ECE/TRANS/WP.29/GRPE/2009/18
31 March 2009

Regulation No. 101

Proposal for draft amendments to Regulation No. 101

Submitted by the expert from Germany¹

Figures 10/2 and 10/3: Parameters measured during emissions test during and between cycles where regeneration occurs (schematic example)

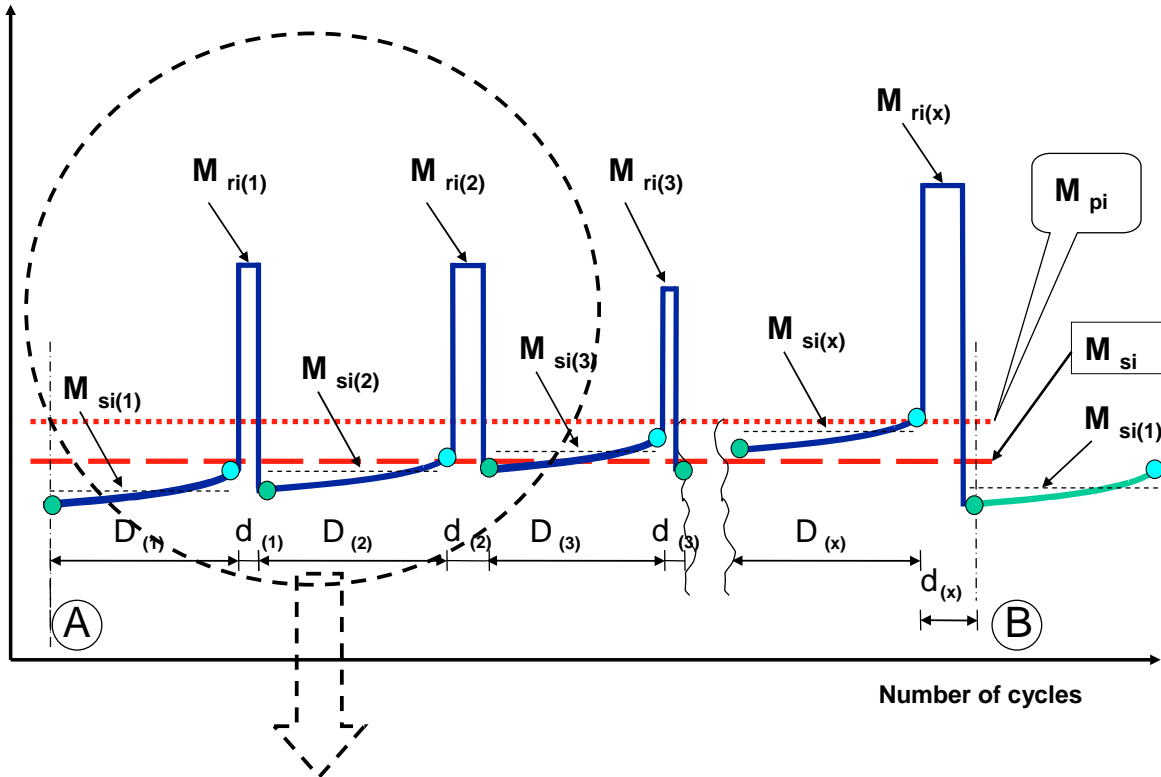
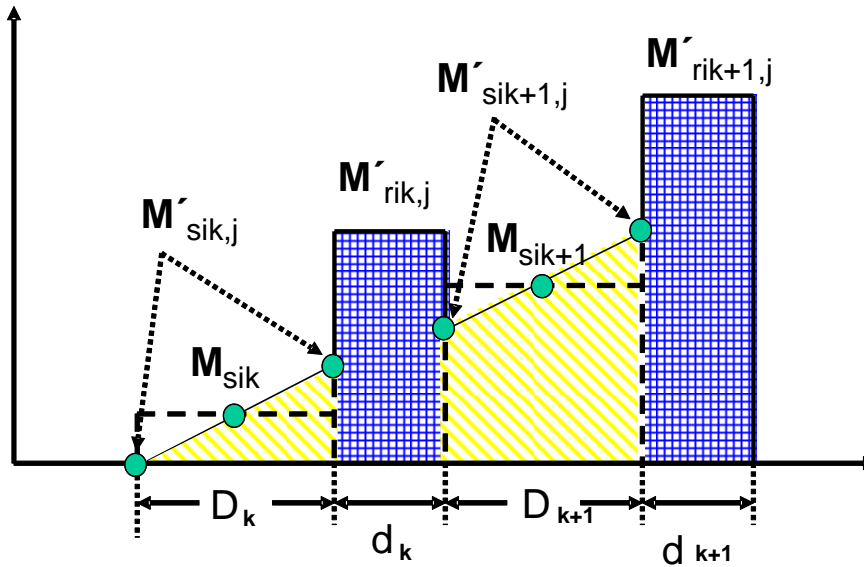
For an illustration of measurement parameters see Figure 10/2 (below)

For more details of the schematic process see Figure 10/3

For application of a simple and realistic case, the following description gives a detailed explanation of the schematic example shown in Figure 10/3 above):

The calculation of the factor (K_i) for multiple periodic regenerating systems is only possible after a certain number of regeneration phases for each system. After performing the complete procedure (A to B, see Figure 10/2), the original starting conditions A should be reached again.
